# Site Accessibility Evaluation

## Lone Tree Shed

**118 W Kirkpatrick St  
Lone Tree, IA 52755**

***Inspection Date: 04/24/2019***

### Finding: 2

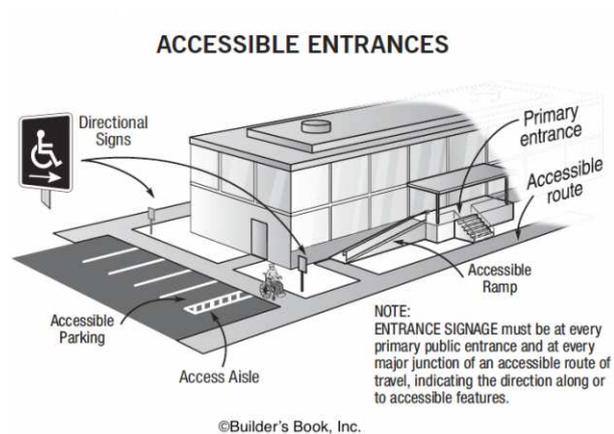
There is no accessible route between the buildings.

gravel lot, no AR to each bldg

Create AR with crushed and compacted stone or similar outdoor material from building to building within the site

**Finding: 3**

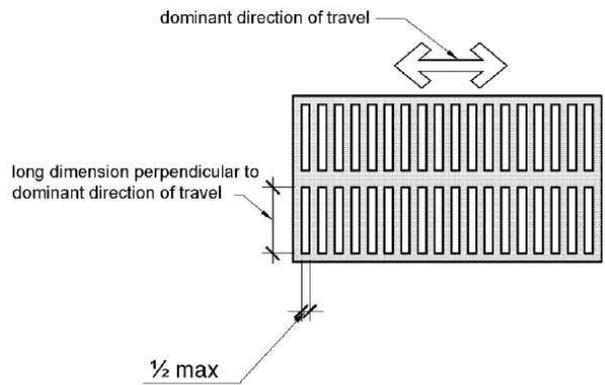
There is a gap spaced greater than a 1/2 inch.

2" gap near door

Correct or fill gaps to be max .5"

### Finding: 6

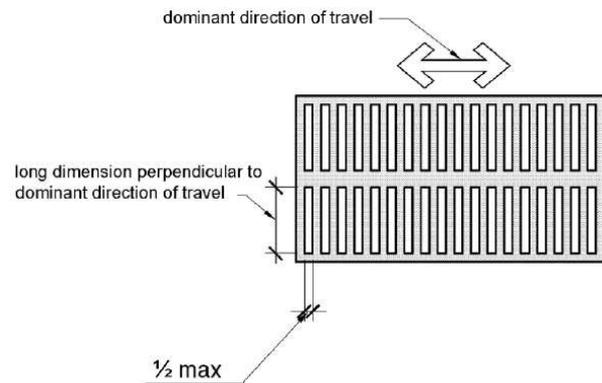
Gratings are spaced greater than a 1/2 inches in the direction of traffic flow.

1" in shed

Replace grate with one having max openings of 1/2 inch.

### Finding: 7

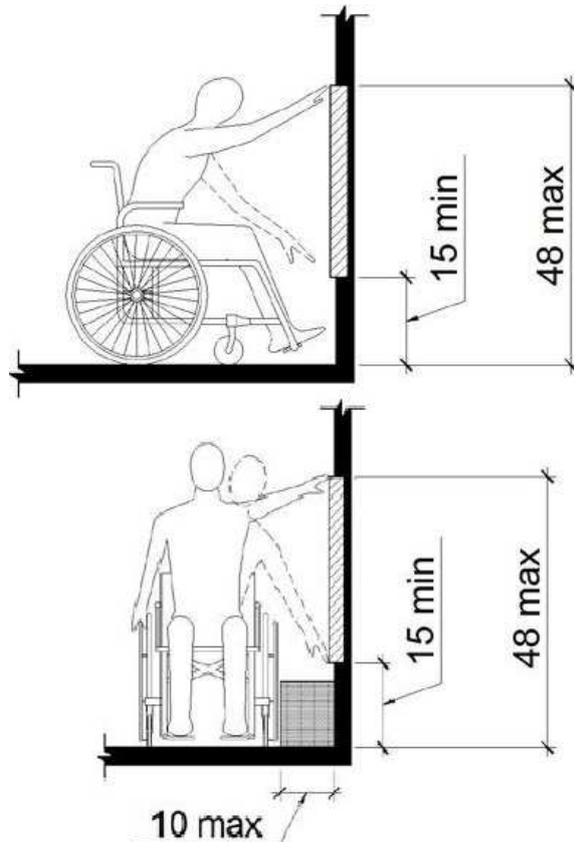
The controls and lockout tags are positioned too high for either a side or front approach.

controls high, lockout tags high

For deficit, leave as is, employee work area pursuant to 2010 Standards 106.5 Defined Terms, until an employee with a disability works here

### Finding: 8

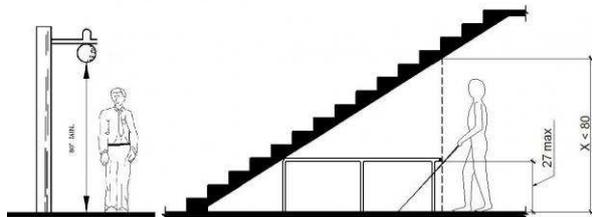
The fire extinguisher projects more than 4 inches into the circulation path.

fire extinguisher in shop 6"

For deficit, leave as is, employee work area pursuant to 2010 Standards 106.5 Defined Terms, until an employee with a disability works here

### Finding: 10

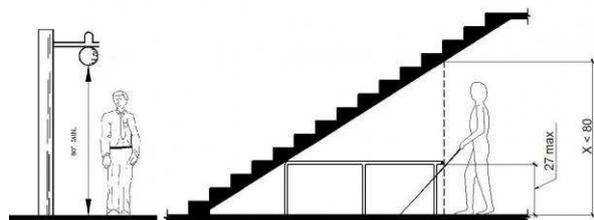
The shelves and cabinet projects more than 4 inches into the circulation path.

shelves protrude  
6.25" and 12", cabinet  
12.5"

For deficit, leave as is, employee work area pursuant to 2010 Standards 106.5 Defined Terms, until an employee with a disability works here

### Finding: 11

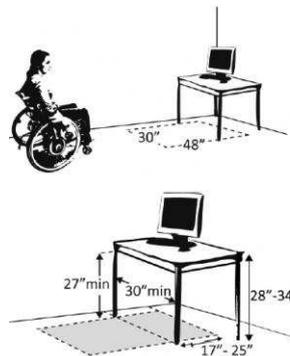
Compliant knee and toe clearance is not provided at the accessible table.

break area table lacks  
toe clearance

Replace the table with one providing required knee and toe clearances

### Finding: 12

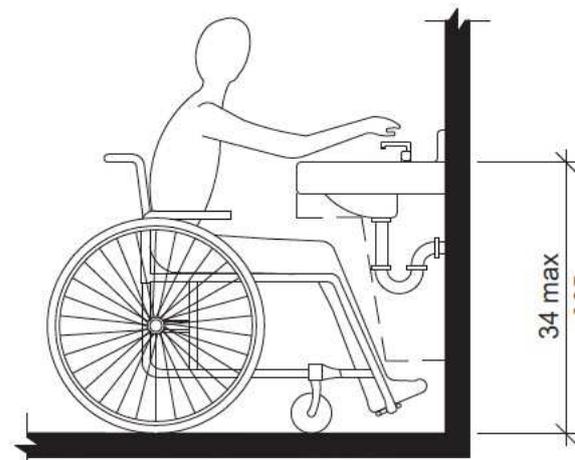
The sink is not accessible.

break area sink height  
38"

Lower sinks to max 34" aff to front of rim

### Finding: 13

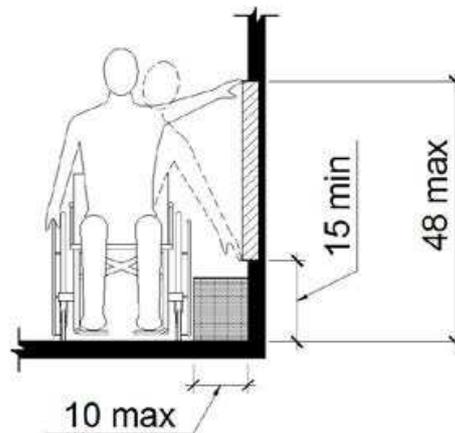
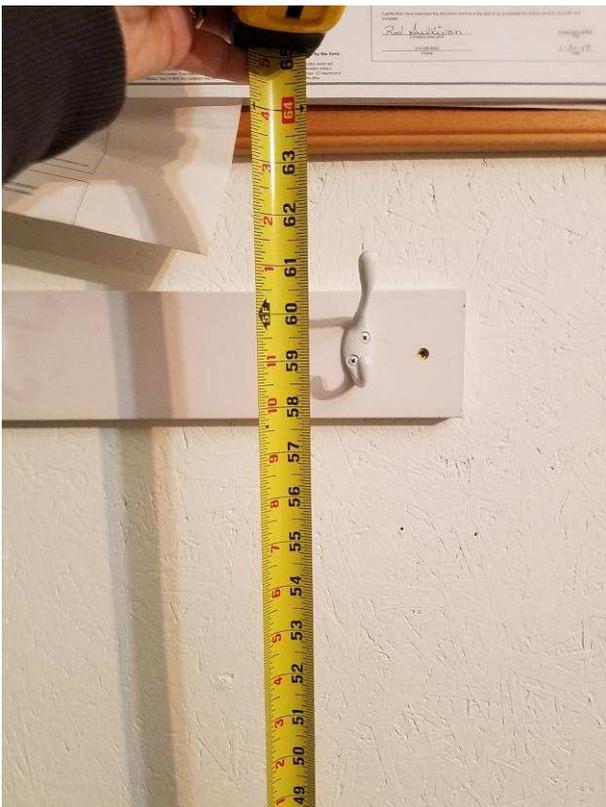
The phone shelf is too high and is out of the maximum reach range for a side approach.

phone shelf too high,  
hooks high at 59 in

Lower operating mechanisms to max 48" aff to highest operable part; leave as is if employee only operated
